SUBJECT: AMENDMENT NO. 82 TO FACILITY OPERATING LICENSE NO. NPF-30  
(TAC NO. M83955)

Callaway Plant  
Unit No. 1

AMENDMENT TO FACILITY OPERATING LICENSE

SAFETY EVALUATION BY THE OFFICE OF NUCLEAR REACTOR REGULATION  
RELATED TO AMENDMENT NO. 82 TO FACILITY OPERATING LICENSE NO. NPF-30

FIGURE 3.9-1  
MINIMUM REQUIRED FUEL ASSEMBLY BURNUP AS A FUNCTION  
OF INITIAL ENRICHMENT TO PERMIT STORAGE IN REGION2

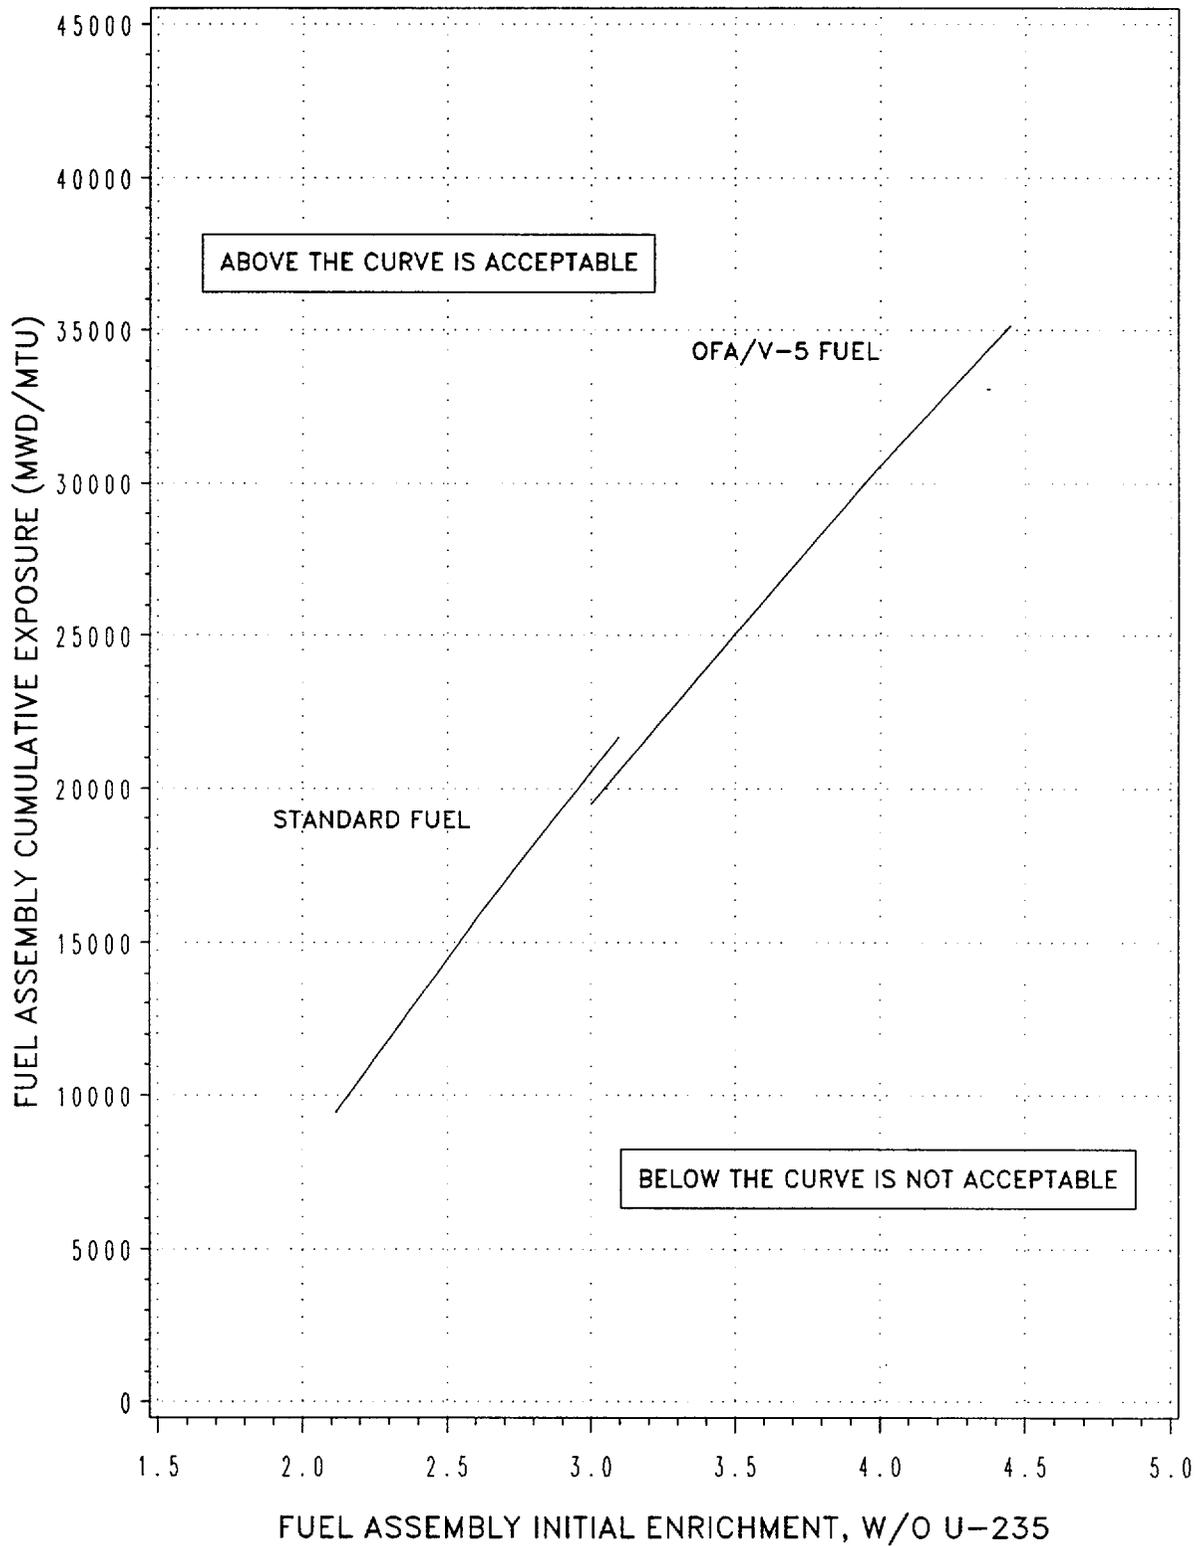
The amendment revises the Technical Specification Section 3/4.9.12, Figure 3.9-1 to reflect a maximum initial enrichment of 4.45 w/o U-235 for fuel storage in Region 2 of the Callaway spent fuel pool.

By application for license amendment dated June 12, 1992, and clarifying information dated August 31, 1992, Union Electric Company (the licensee) requested changes to the Technical Specification (TS) Section 3/4.9.12, "Spent Fuel Assembly Storage," for the Callaway Plant, Unit 1. The amendment would replace Figure 3.9.1, a graph of fuel assembly cumulative exposure (MWD/MTU) versus fuel assembly initial enrichment. The change would reflect an increase in the maximum initial U-235 enrichment for storage in Region 2 of the spent fuel pool. The current maximum allowable enrichment of 4.25 w/o U-235 would be increased to 4.45 w/o U-235.

The staff has reviewed the submittal for the spent fuel assembly storage technical specification change and determined that the methodology used was acceptable. Figure 3.9-1 will be used to determine if a fuel assembly with an initial U-235 w/o enrichment up to 4.45 enrichment that has undergone a

determined exposure can be stored in Region 2 of the storage racks. The review has concluded that the spent fuel pool criticality analysis is in accordance with staff positions, and that storage of Callaway Plant fuel assemblies in Region 2 using the proposed limiting exposure curves is acceptable.
